MFN 07-597

Docket No. 52-010

Subject: **Response to Portion of NRC Request for Additional Information Letter No. 101 Related to ESBWR Design Certification Application - Design of Structures, Components, Equipment, and Systems - RAI Numbers 3.4-10 and 3.4-11**

RAI Numbers 3.4-10 and 3.4-11

Figure 3.4-10 (1) Typical Sketch of Waterproofing at Personnel Access Opening

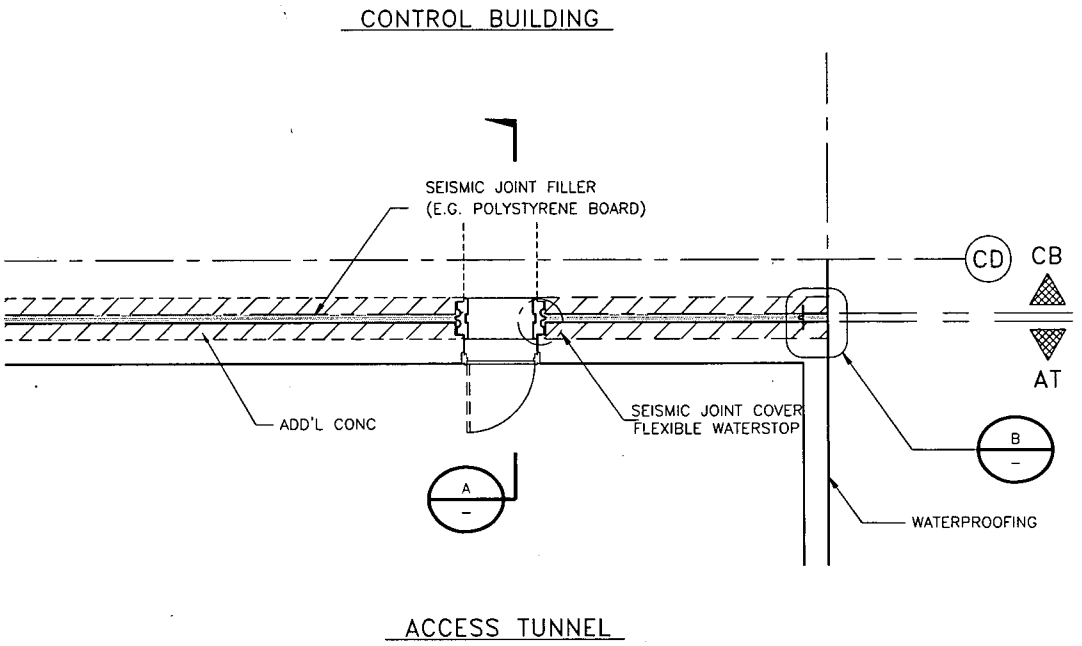
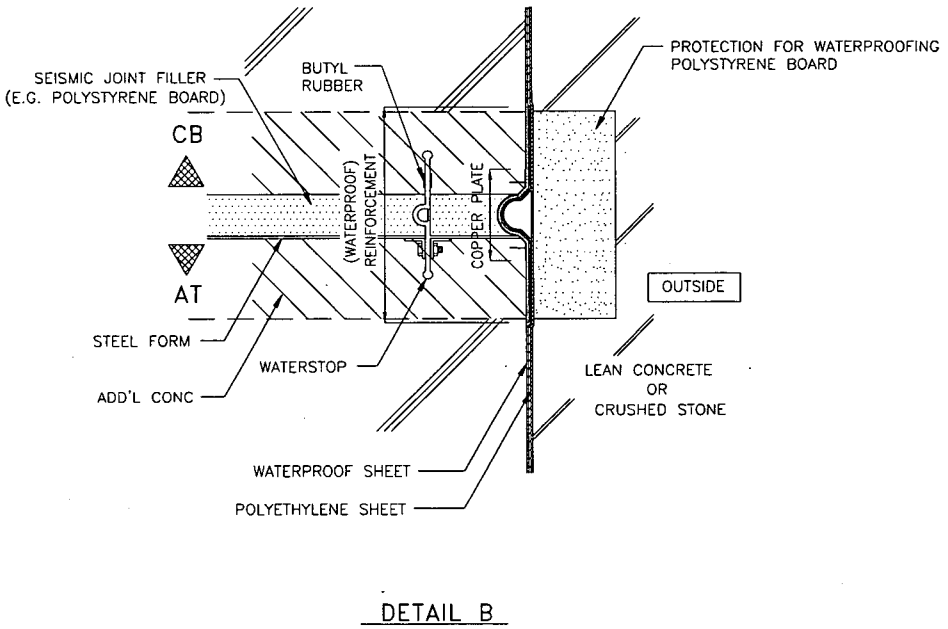
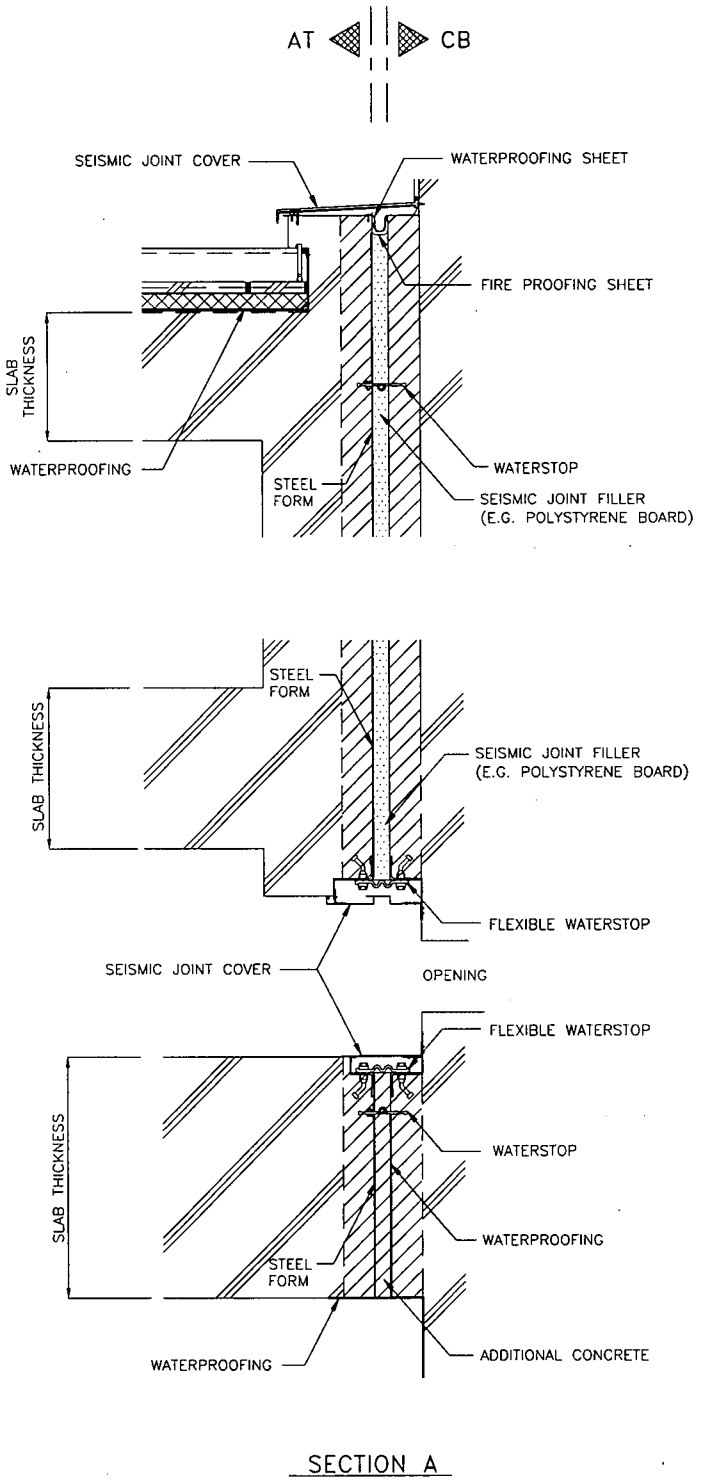
Referring to Table 3.4-1 of the ESBWR DCD Tier 2, Rev. 3, provide a listing of penetrations below design flood level that go through the reactor, fuel and control buildings (including the access opening at control building access to reactor building at tunnel), and typical sketches of the penetrations/access opening depicting how the water-leak tight function of the seals is ensured against the hydrostatic pressure head due to the design flood or ground water. Also indicate if bellows are used for some large diameter penetrations to accommodate for the potential differential displacement effects.

Locations of penetrations below design flood level that go through the reactor, fuel, and control buildings are determined during the detailed design. Personnel Access opening at control building access to reactor building at tunnel is provided in DCD Tier 2, Rev. 4, Figure 1.2-3.

Figure 3.4-10 (1) shows a sketch of the personnel access opening. The water-leak tight function is ensured by the membrane waterproofing applied on exterior concrete surfaces and waterstops installed between two adjoining buildings.

Figure 3.4-11 (1) Comparison of Distributions of Soil Pressures

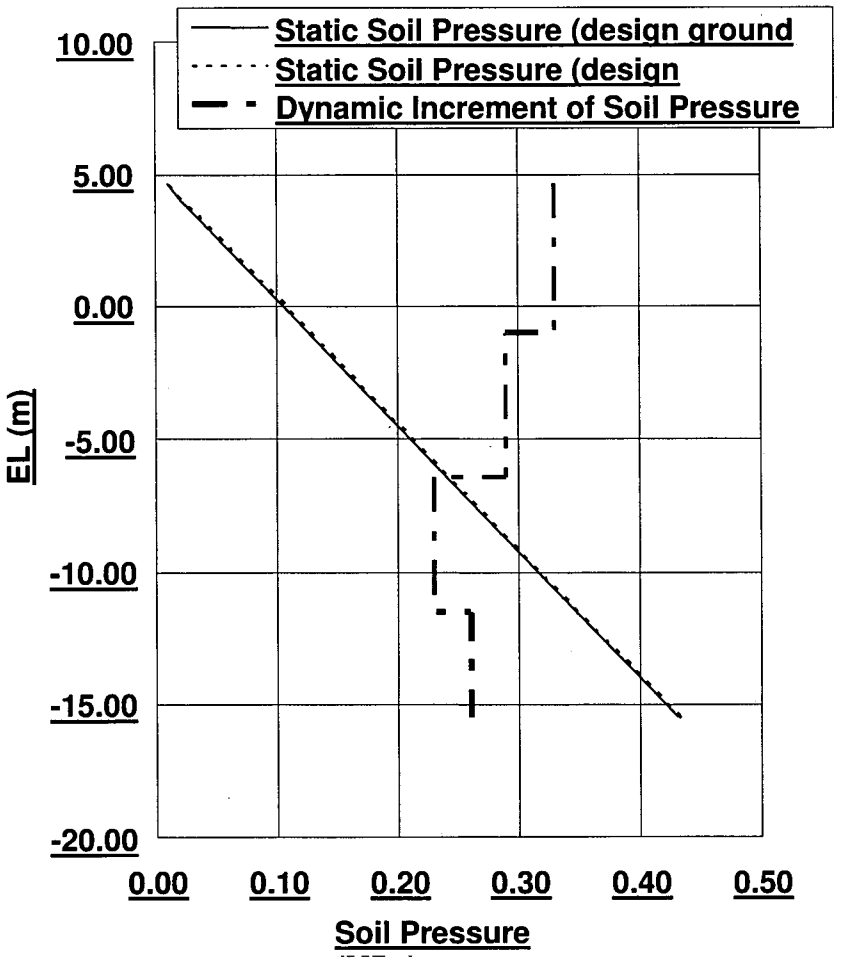
The last paragraph of ESBWR DCD Tier 2, Rev. 3, Section 3.4.2 states that the lateral hydrostatic pressure on the structures due to the design flood level, as well as ground water and soil pressure, are factored into the structural design in accordance with SRP 3.4.2. The paragraph further refers to DCD Tier 2, Appendix 3G, Design Details and Evaluation Results of Seismic Category I Structures, for more specific design information. Provide a discussion of the specific steps adopted in accounting for the lateral hydrostatic pressure due to the design flood level, as well as ground water and soil pressure for the embedded areas of the reactor and fuel buildings including references to pertinent quantitative analysis results of Appendix 3G to DCD Tier 2.

The design flood level is 310 mm (1ft.) higher than design groundwater level. Figure 3.4-11 (1) shows the static soil pressure (including hydrostatic pressures) for the design groundwater level (610 mm (2 ft.) below design plant grade) during the normal operation and design flood level (310 mm (1 ft.) below design plant grade) for flood conditions. The difference between the two conditions is very small. According to Article 9.2.7 of ACI 349-01, to which the design of the Safety-Related concrete structures conforms, the design flood is considered in Nos. 6 or 7 combinations in DCD Tier 2, Rev. 4, Table 3.8-15. In the load combinations including E', dynamic increments of soil pressures need to be considered together with the static soil pressures (including design ground water hydrostatic pressures) during the normal operation. The distribution of the dynamic increment of soil pressure is also indicated in Figure 3.4-11 (1), and its magnitude is much larger than the differences between the static soil pressures during normal operation and flood conditions. Because soil pressures during flood conditions are enveloped by those due to the SSE, they do not govern the design.

The description for load, H, provided in DCD Tier 2, Rev. 4, Subsection 3.8.4.3.1.1 will be clarified.
